PARTS & SERVICE NEWS

REF NO.	AA03091A
DATE	July 14, 2003

- SUBJECT:** AIR TO AIR COOLER CRACK REPAIR AND REWORK
- PURPOSE:** To inform the field of a procedure to repair cracks found on the air to air cooler.
- APPLICATION:** Komatsu HD785-5LC Dump Trucks A10144, A10224, A10228 and Up
- FAILURE CODE:** 0100HA
- DESCRIPTION:** Radiator Assembly Kit With Aftercooler Isolator (XK0223)

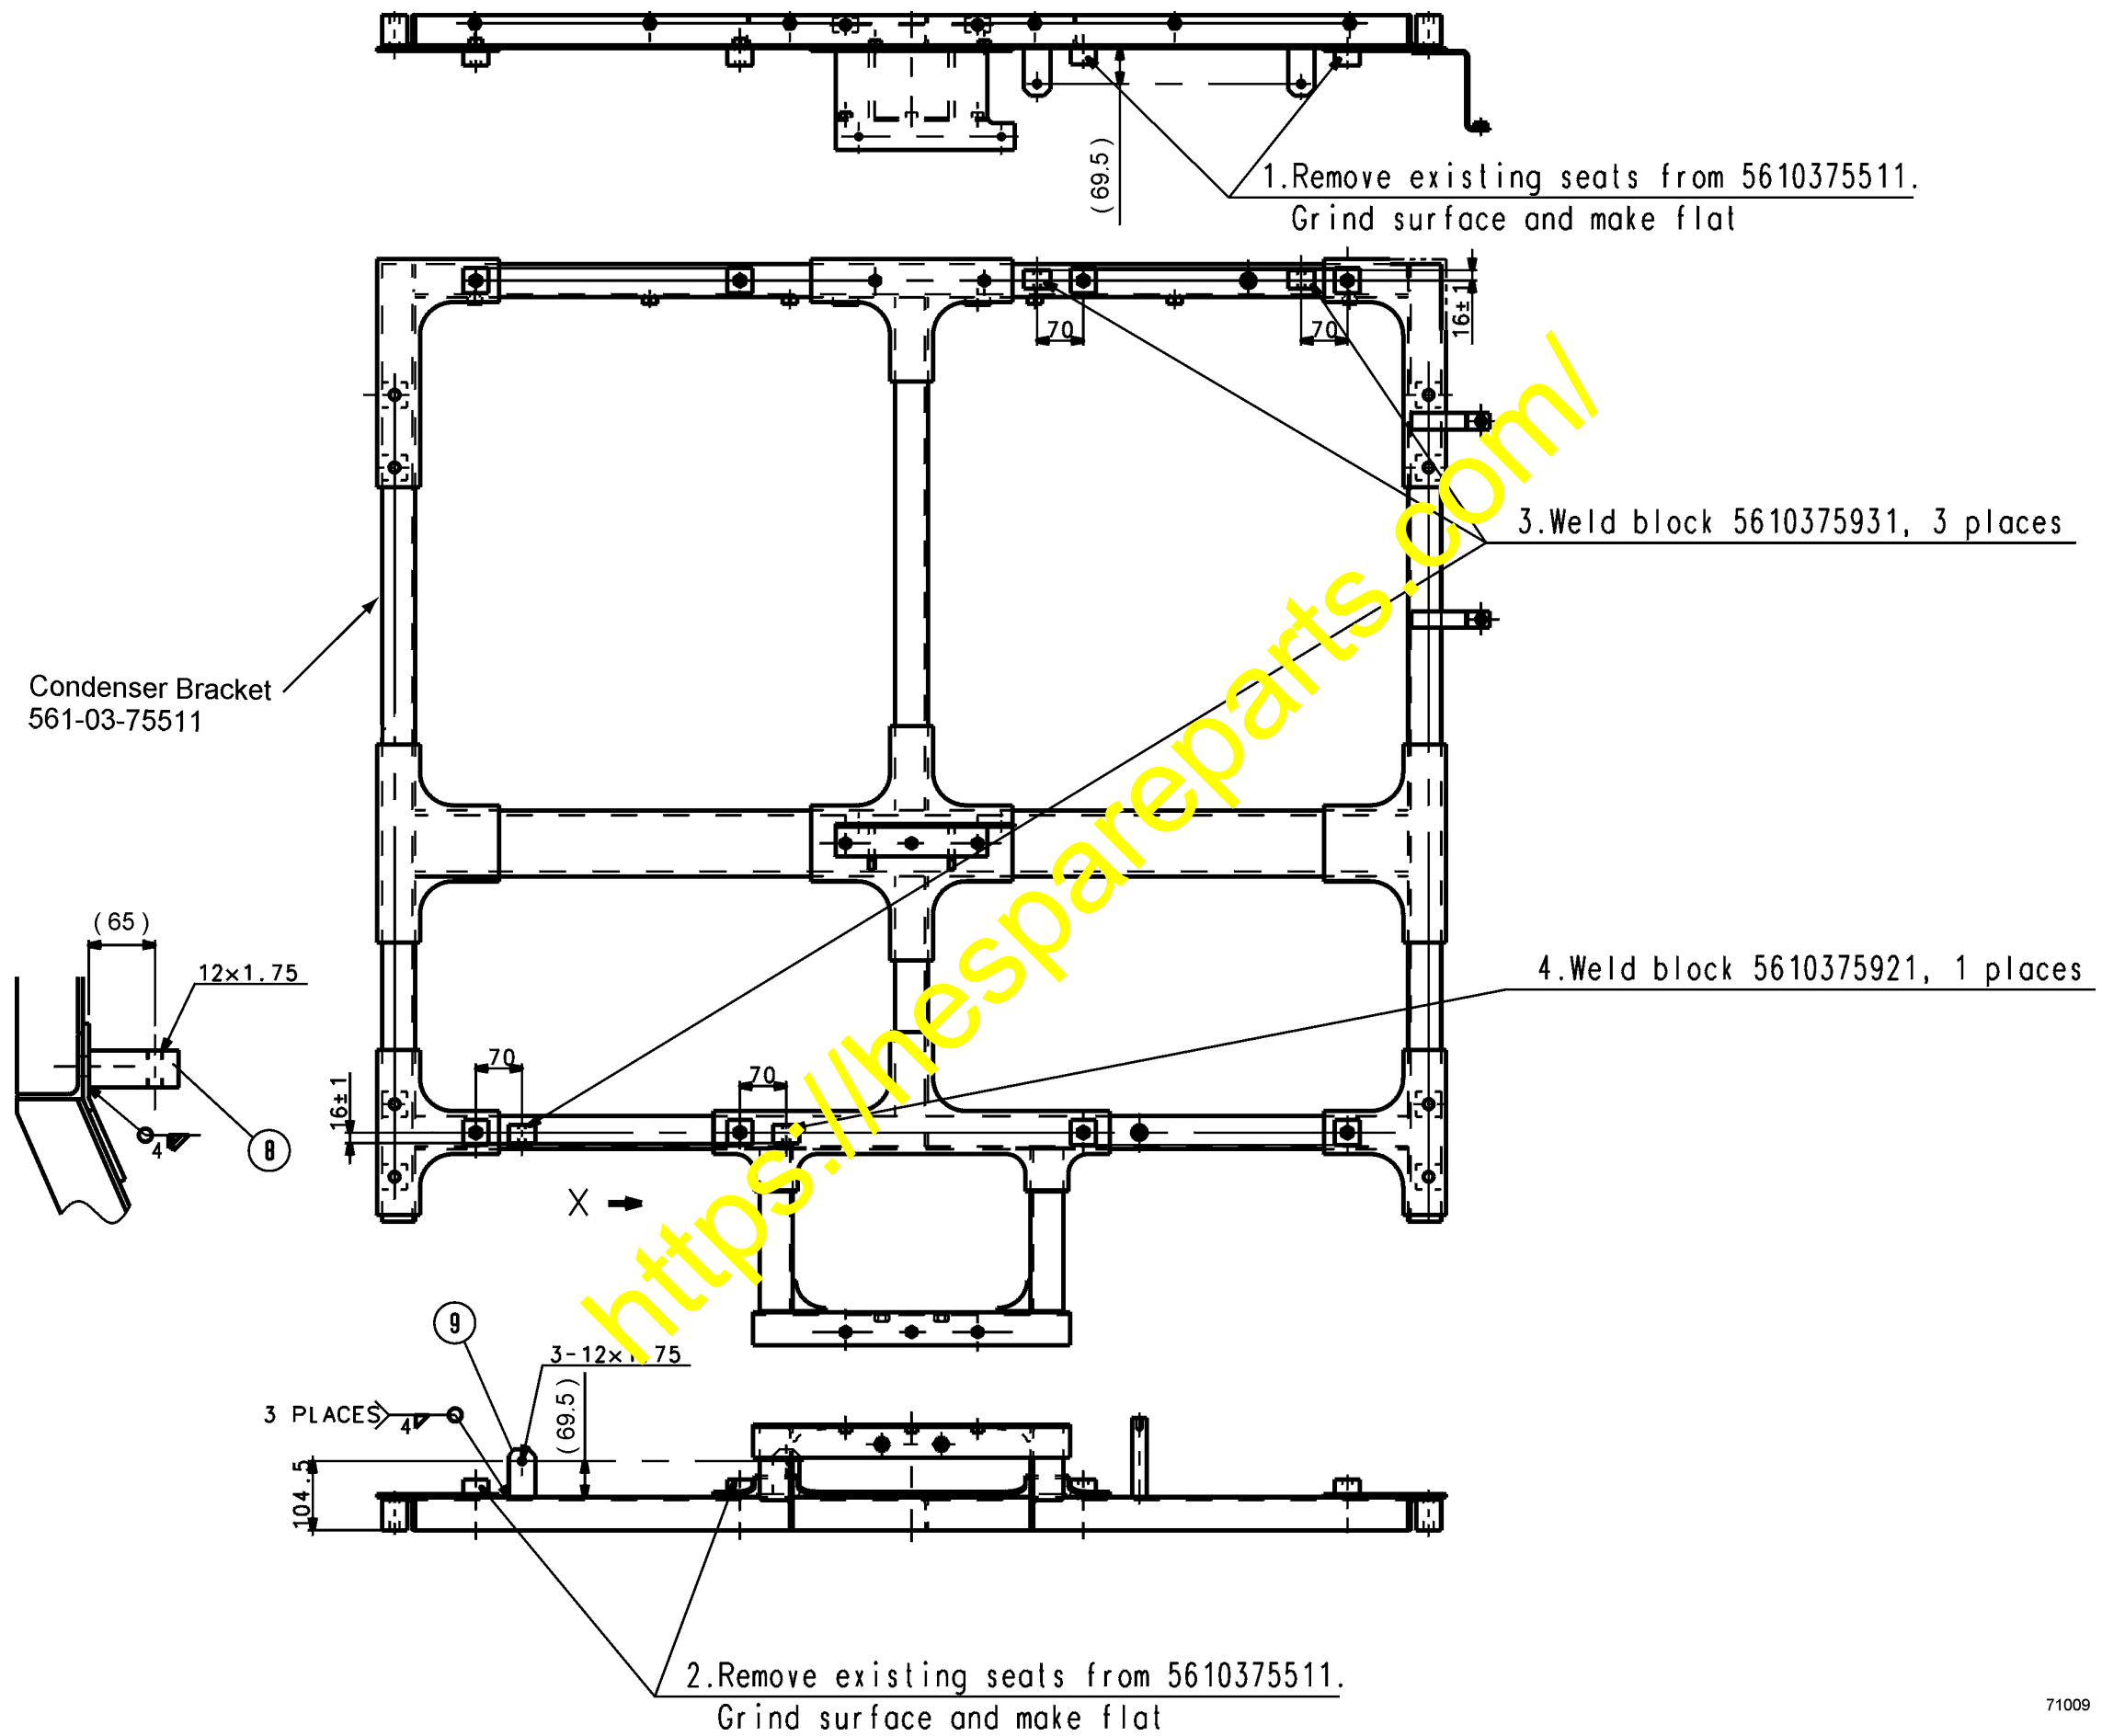
This Parts & Service News introduces a new kit (XK0223) that is used to prevent cracks in the air to air cooler. The contents of the kit are listed in Table 1. Refer to Figure 1 for an illustration of condenser bracket modification. Refer to Figure 2 for an illustration of rubber mount installation.

INSTALLING RUBBER MOUNT TO AIR TO AIR COOLER:

1. Remove radiator grill. Refer to appropriate shop manual, Section B.
2. Remove steering cooler. Refer to appropriate shop manual, Section C.
3. Remove condenser cooler. Refer to appropriate shop manual, Section C.
4. Remove condenser bracket 561-03-75511.
5. Remove both air to air coolers 621-26-24100.
6. Modify condenser bracket 561-03-75511. Refer to Figure 1.
7. Install two air to air coolers with rubber mount 561-03-75901. Refer to Figure 2.
8. Assemble steering cooler, condenser, grill. Refer to appropriate shop manual, Sections B and C.
